# Preapplication Safety Evaluation Report for the Power Reactor Innovative Small Module (PRISM) Liquid-Metal Reactor

Final Report

Manuscript Completed: January 1994  
Date Published: February 1994

Office of Nuclear Reactor Regulation  
U.S. Nuclear Regulatory Commission  
Washington, DC 20555-0001

Figure 5.13 Alternative flow model for blockage of RVACS inlets

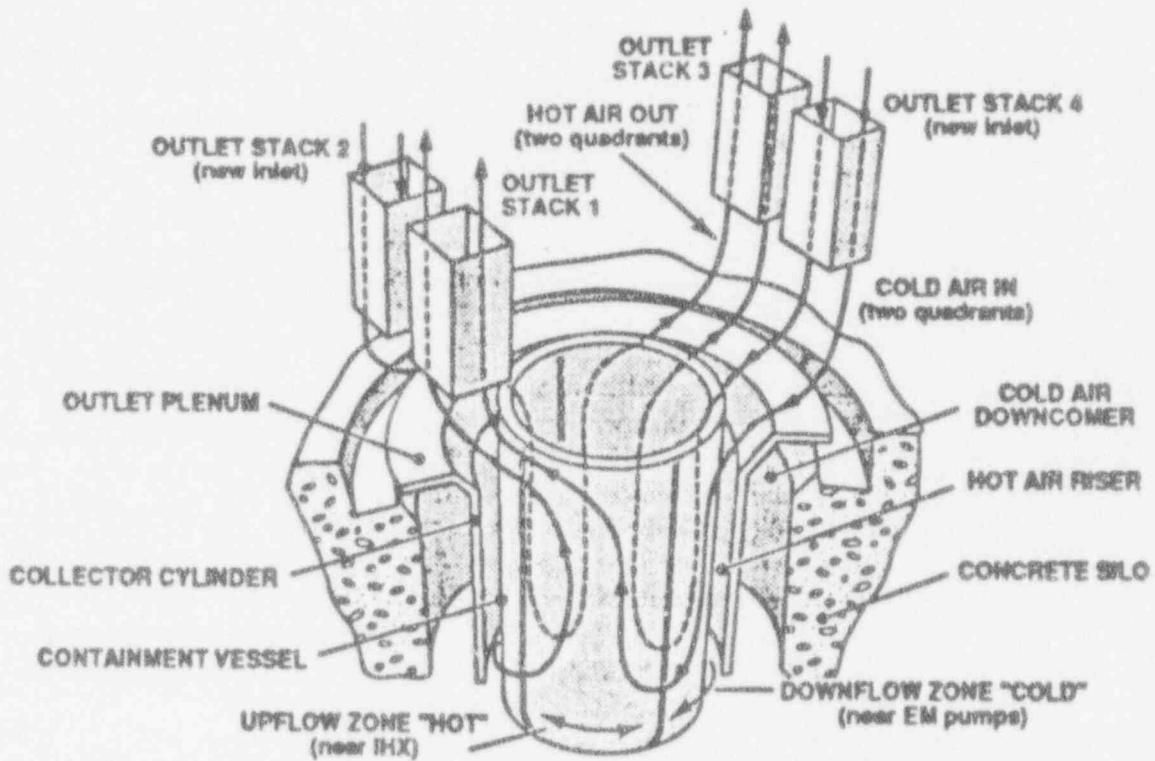
For a blockage of just the inlets, an alternative method of heat transfer becomes important. This method is shown in Figure 5.13. In this case, two of the four outlets would become inlets. Air would still circulate by natural convection; however, air would circulate downward near the cool sodium of the EM pumps, and would rise near the hotter sodium of the IHX. Hence, the two outlets near the EM pumps would become inlets, and the outlets near the IHXs would remain outlets. The designer has stated that maximum temperature at the core outlet would reach 904 K (1168 °F), below Level C limits, and that uncertainties in the analysis might increase this temperature

Figure 15.4 PRISM reactor changes to enhance accident mitigation capability

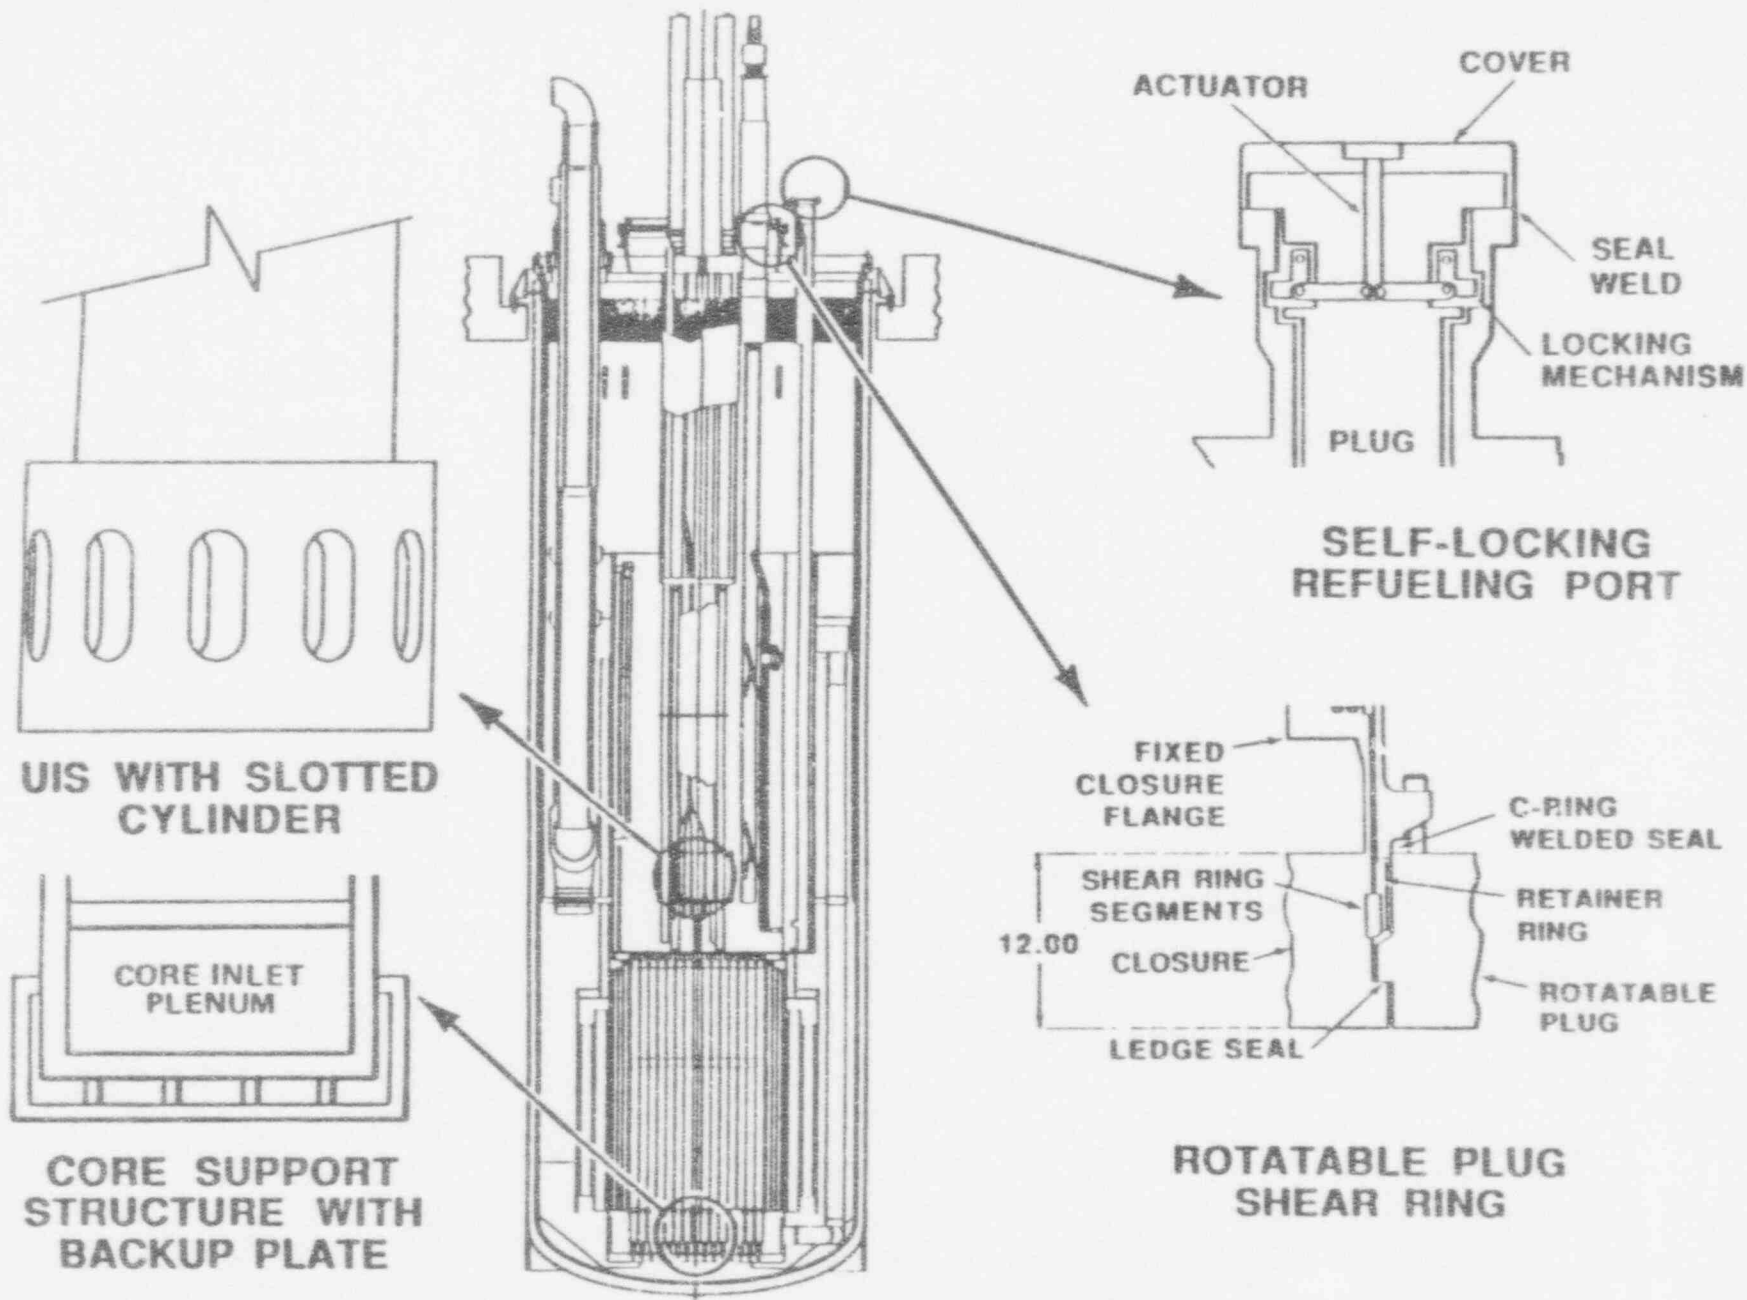
Several design changes are now under consideration to enhance the ability of the reactor to contain the consequences of an HCDA and/or a core melt accident within the primary system boundary. Several specific hardware features, to address HCDA energetics and core melt, under consideration, shown in Figure 15.4, are:

Figure B.2 Summary of GE Bounding Events 1A, 1B, 2', and 4

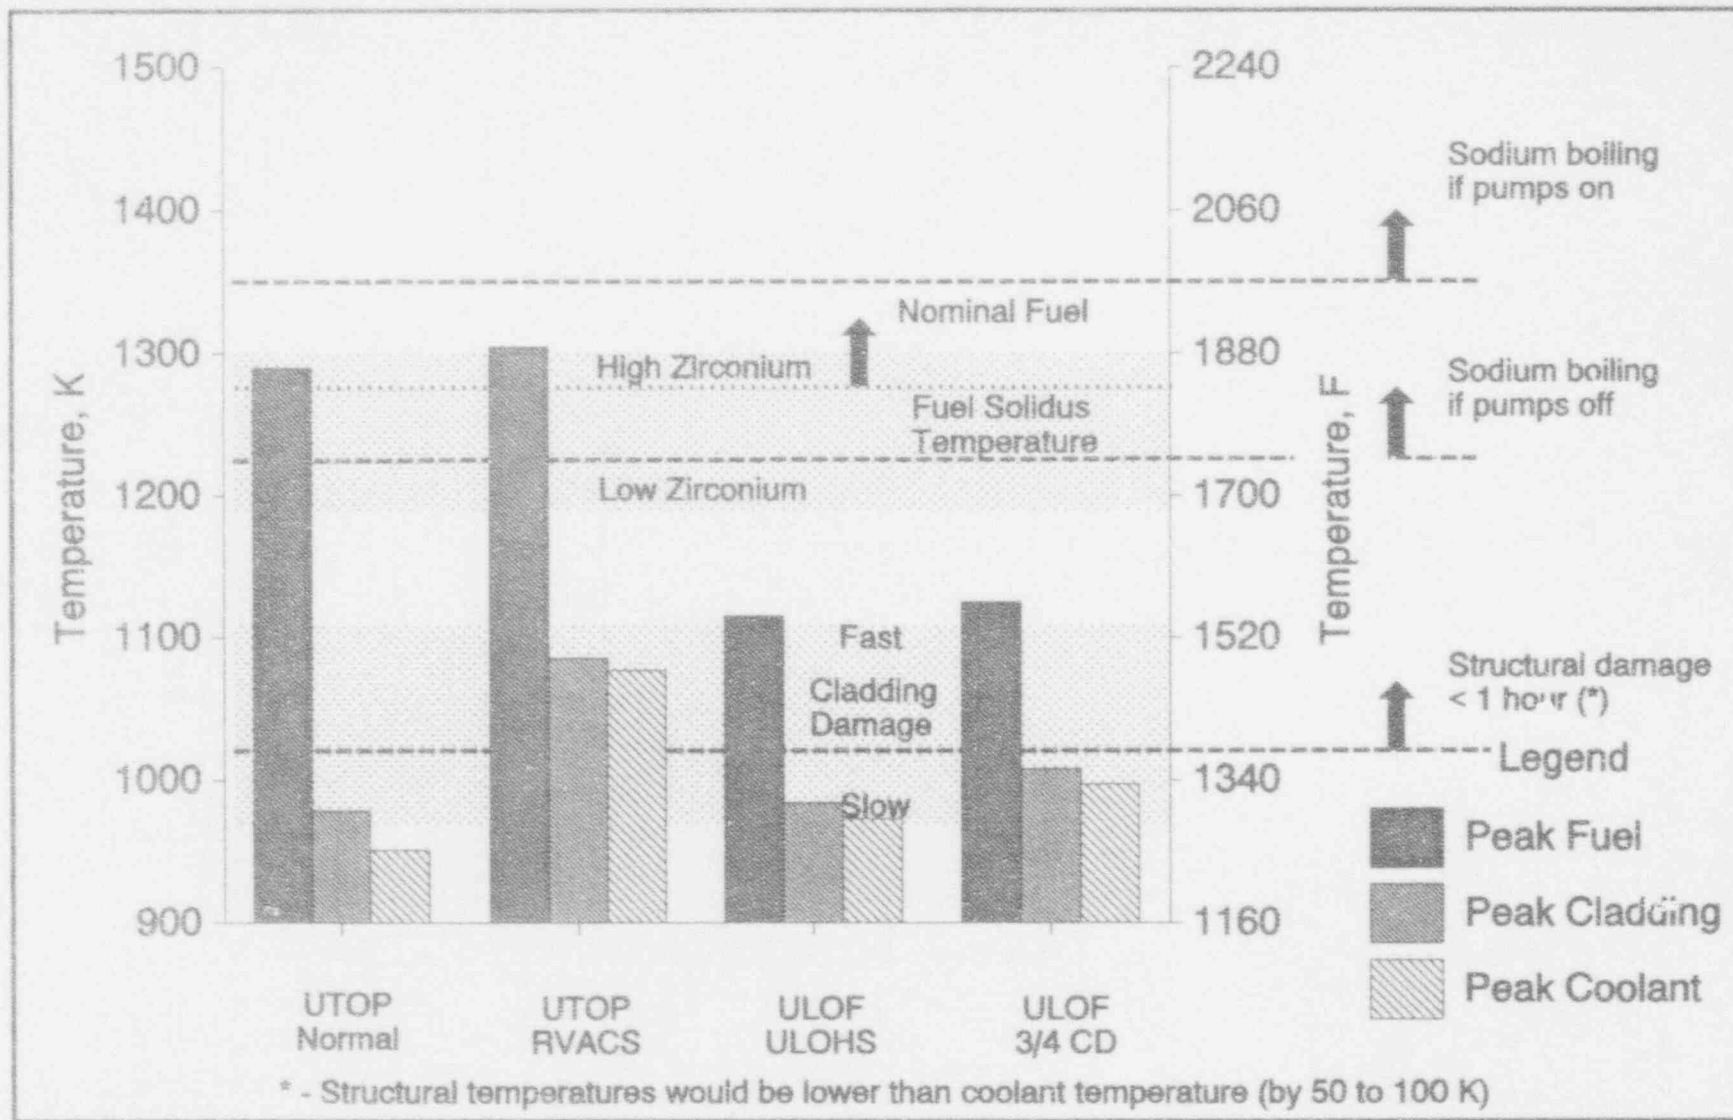
It is clear from Figure B.2 that some fuel would be heated above the solidus temperature for BE-1A and -1B. For the UTOP events, the power production in the pins increases by about 70 percent, so the pin center-line temperatures can increase very substantially. As the peak fuel temperatures for BE-1A and BE-1B are above the solidus temperature for the zirconium fuel, there is little doubt that some localized melting would take place. A decision will be required at the design certification stage, in terms of how much, if any, localized fuel melting will be acceptable.

The ULOF-ULOHS (BE-2') and ULOF-3/4 coastdown (BE-4) events on the right side of Figure B.2 result in significantly lower fuel temperatures. There may be a very slight amount of cladding damage for these events, especially if conservative limits are applied. The sodium is well below boiling, with or without pumping. A major factor in limiting the peak temperatures is the use of the GEMs to insert a large amount of negative reactivity once the pumps trip off line.

The GE results presented in PSID Section G.4.16.2, as summarized in Figure B.2 point directly to the postulated UTOP events as the safety concerns within the category of "bounding events." Independent analyses performed at Brookhaven National Laboratory (BNL) (Ref. B.5) tend to confirm this, although BNL's peak fuel temperatures are somewhat higher, and the subsequent cladding damage greater. Despite ANL's optimism that it can demonstrate that metal fuel can survive these events, GE may have to consider reducing the potential UTOP initiator below 40°C (including uncertainties), perhaps by moving the control rod stops more frequently. Because the preapplicant seems to have a few options available to reduce the potential UTOP initiators, the results summarized in Figure B.2 are not viewed as an insurmountable problem.
